UNITED STATES
NUCLEAR REGULATORY COMMISSION
WASHINGTON, D.C. 20555-0001

FACILITY: Diablo Canyon Power Plant, Unit Nos. 1 and 2

SUBJECT: SUMMARY OF JUNE 13, 2012, TELECONFERENCE MEETING WITH PACIFIC GAS AND ELECTRIC COMPANY ON DIGITAL REPLACEMENT OF THE PROCESS PROTECTION SYSTEM PORTION OF THE REACTOR TRIP SYSTEM AND ENGINEERED SAFETY FEATURES ACTUATION SYSTEM AT DIABLO CANYON POWER PLANT (TAC NOS. ME7522 AND ME7523)

Figure 1 DCPP 120 Volt Vital Instrument AC System (Simplified)

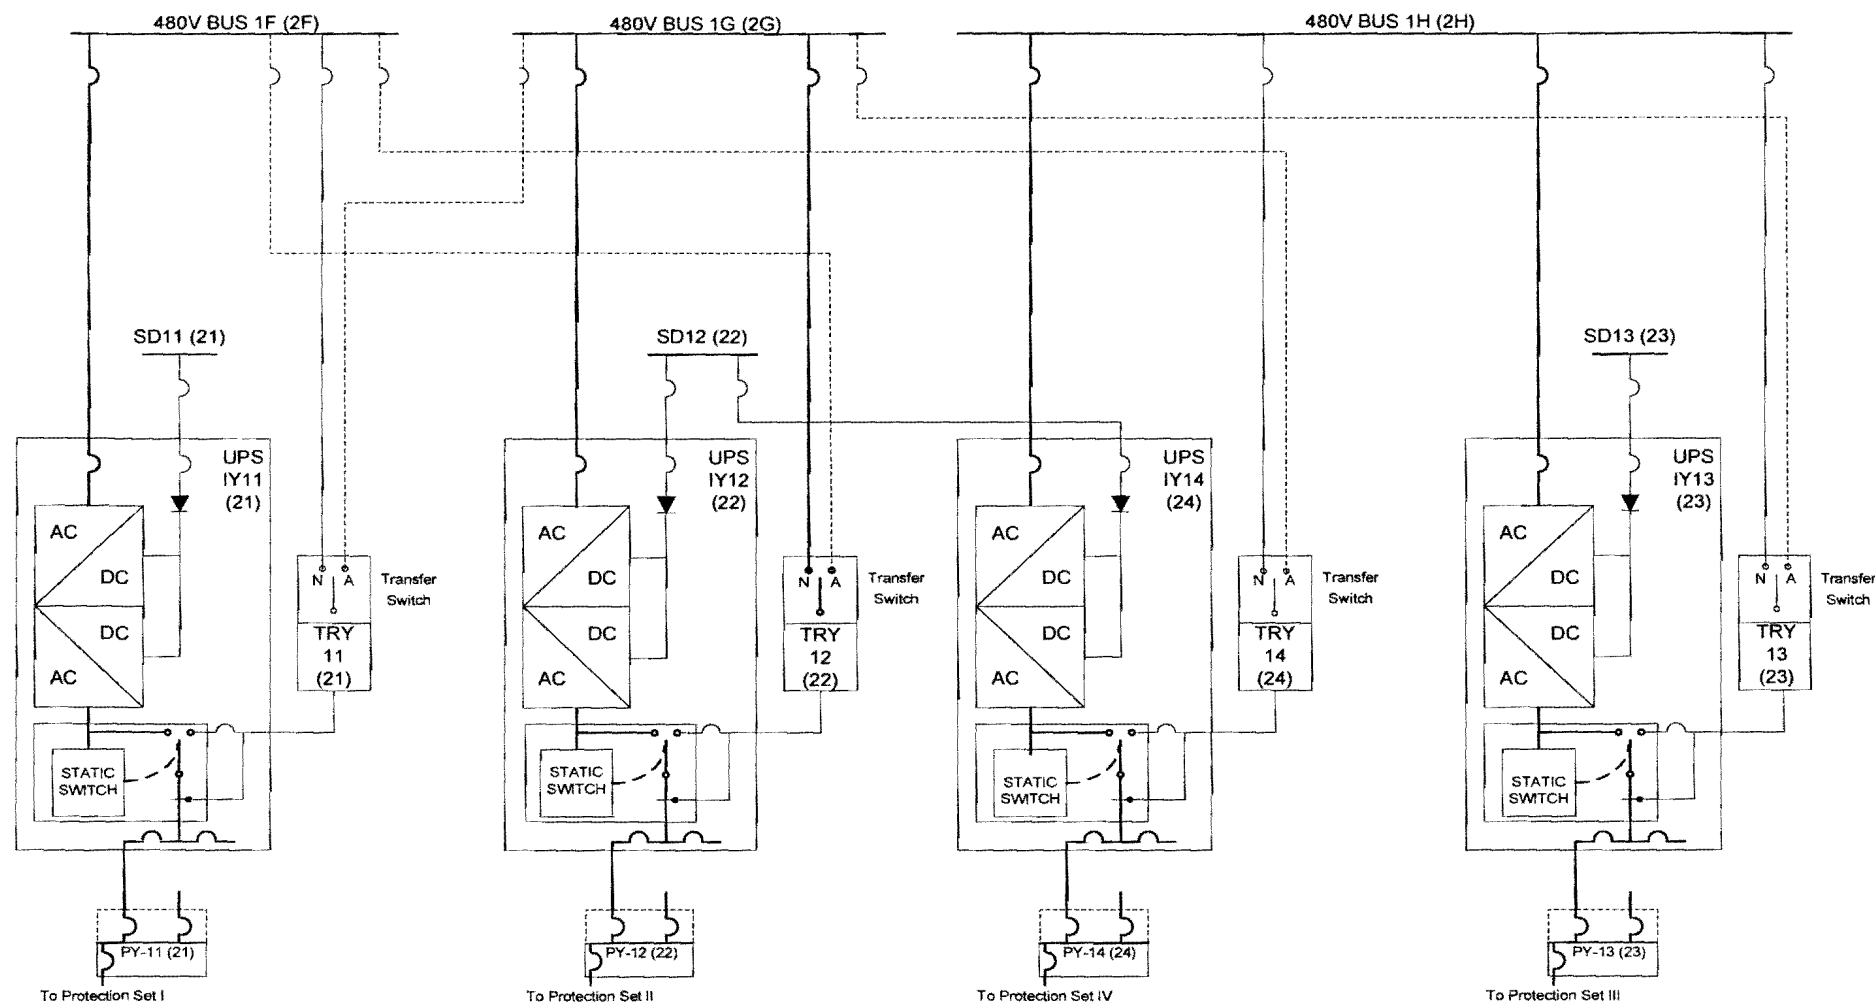
No	Src/RI	Issue Description	P&GE response:	Status	RAI No. (Date Sent)	RAI Response (Due Date)	Comments
32	RJS	<p>Section 4.2.7 "Power Supply" of the LAR describes how power is supplied to the PPS. In this description, the 480V AC vital supply is described in the following ways.</p> <ul style="list-style-type: none"> • First it is described as back-up common bus to the 120 V distribution panels. We cannot tell if this is through a transformer or if this refers to the alternate supply to the inverters. • It is also described as a supply to an inverter. • It is then described as supply to the battery charger <p>From these descriptions, it is not clear to the staff how these vital power sources are configured in relation to the 120VAC panels that feed the PPS. Would it be possible to provide a simplified diagram to show the relationship between the 125V Batteries / DC Buses, Battery Chargers, Inverters, and the 120V AC distribution Panels that supply power to the PPS,</p>		Open	RAI 16		PGE Response accepted.

<p>PG&E response:</p> <p>The following description clarifies the 120 V vital instrument AC power supply to the PPS:</p> <ol style="list-style-type: none"> 1 Safety-related 480 VAC from vital AC motor control center (MCC) is fed to the UPS and rectified. 2 Rectifier output is fed to the inverter and converted to 120 VAC. 3 Safety related vital DC bus power is fed to UPS as immediate backup supply. The vital DC bus is backed up by the safety-related 125 VDC station battery, which is charged from vital 480 VAC. 4 Inverter output is fed through a static switch with integral manual bypass switch to vital instrument AC power distribution panels. 5 On loss of inverter output, the static switch will select backup regulating transformer output (120 VAC) to distribution panels. 6 The backup regulating transformer receives input from the 480 VAC supply. The backup regulating transformer may be aligned via a transfer switch to either of two 480 VAC busses; the normal supply or an alternate supply. The alternate supply circuit breaker is normally open to prevent interconnection of redundant power supplies due to a failed

Figure 1 Replacement PPS Acceptance Testing with Overlap

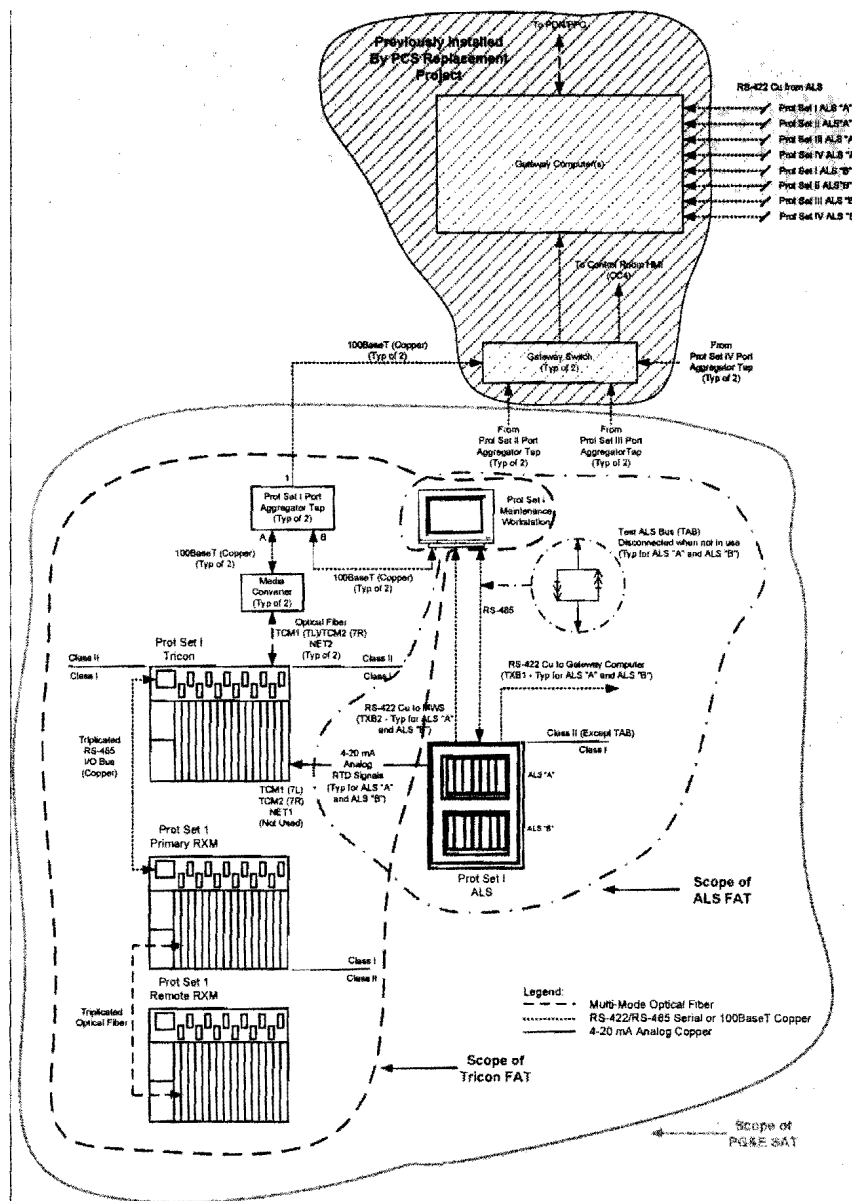
Comment [WEK1]: The staff will need a FAT that tests all MWS functions in an integrated manner. Since the MWS will be permanently attached to / utilized by both the ALS and Tricon Platforms for various functions, how will these functions be tested to demonstrate the full capability of the MWS (see WEK 6 comment)??

Comment [WEK6]: This is still problematic. The staff cannot approve an integrated system without completion of a complete FAT on the entire system. This can be done either at a vendor's facility, or at the licensee's facility—it makes no difference to the staff. However, each FAT activity should be done to the same standards as delineated in ISG-06 and the LAR (e.g., FAT Test Plan (submitted on the Docket), test procedures (available for audit), and test results summarized in a final FAT Report (submitted on the Docket). We need to find a way to resolve this...

Comment [WEK8]: PG&E's SAT activities should be executed as part of the PPS FAT — this test scheme is not responsive to OIR 23.
